**PD Modification Application: PRS 23-0458****Zoning Hearing Master Date:** N/A**BOCC Land Use Meeting Date:** July 18, 2023**Hillsborough  
County Florida**

**1.0 APPLICATION SUMMARY****Applicant:** David Wright / TSP Companies, Inc.**FLU Category:** Suburban Mixed Use-6 (SMU-6)**Service Area:** Urban**Site Acreage:** 0.51 MOL**Community  
Plan Area:** Riverview**Overlay:** Riverview Downtown-Uptown  
Overlay**Introduction Summary:**

**8.0 FULL TRANSPORTATION REPORT****AGENCY REVIEW COMMENT SHEET**

PETITION NO: PRS 23-0458

### 2.4 Proposed Site Plan (partial provided below for size and orientation purposes. See Section 7.2 for full site plan)

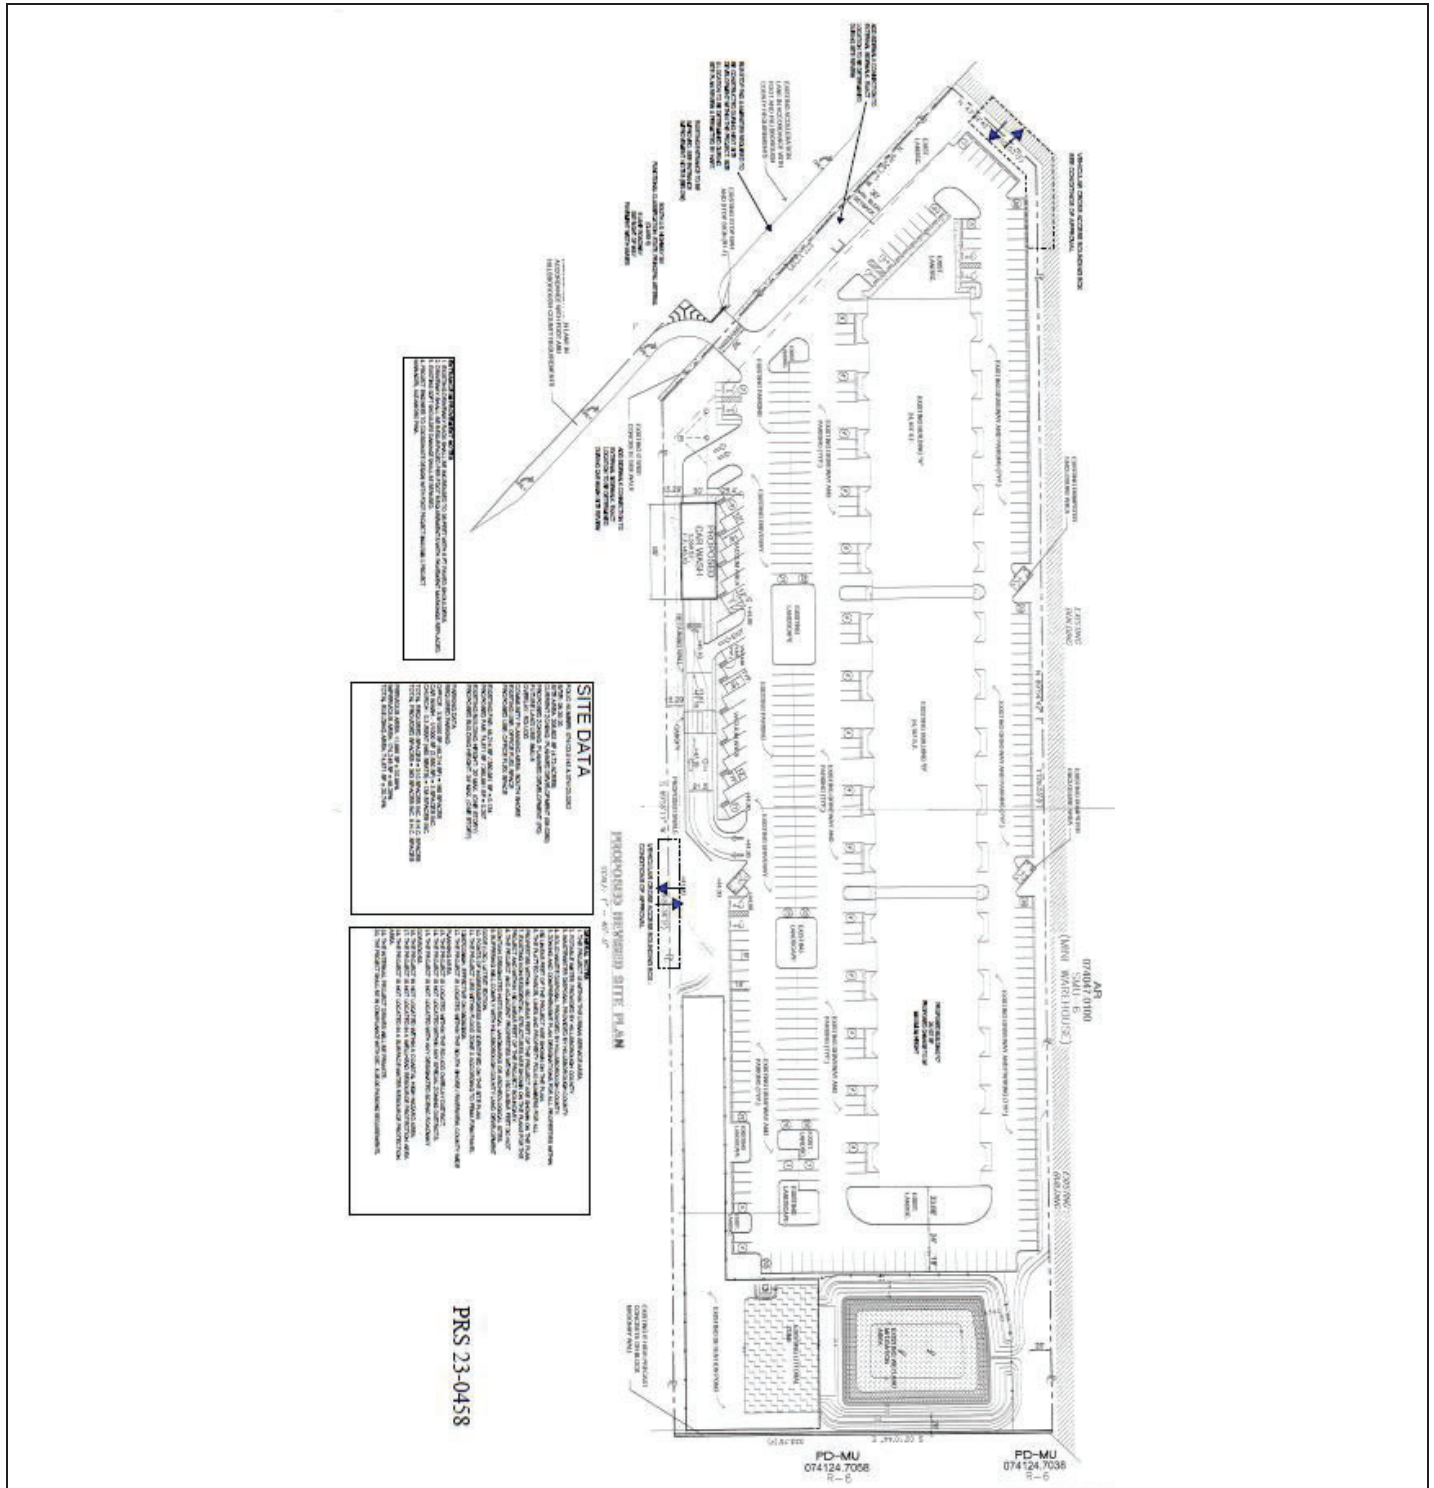
The subject application requests to allow folio # 74123.0143 within PD 05-1787, identified as “Proposed Building C” on the site plan to be permitted a maximum height of 34 feet. No changes are proposed to the entitlements or site plan layout for PD 05-1787. Staff has not identified any compatibility issues related to the request.

The proposed modification requests an increase in height to the eastern most building (Building "C") on folio#74123.0143 from 20 feet to 34 feet for a maximum of 2 stories to accommodate a 460-seat church sanctuary. No increase in FAR is proposed.

- 1.4 Maximum building height 20 feet or one story for Building A and B. Maximum building height of 34 feet for Building C.
  - 1.5 Convenience stores with or without gasoline sales, stand alone banking facilities, or fast food facilities shall not be permitted at this location.
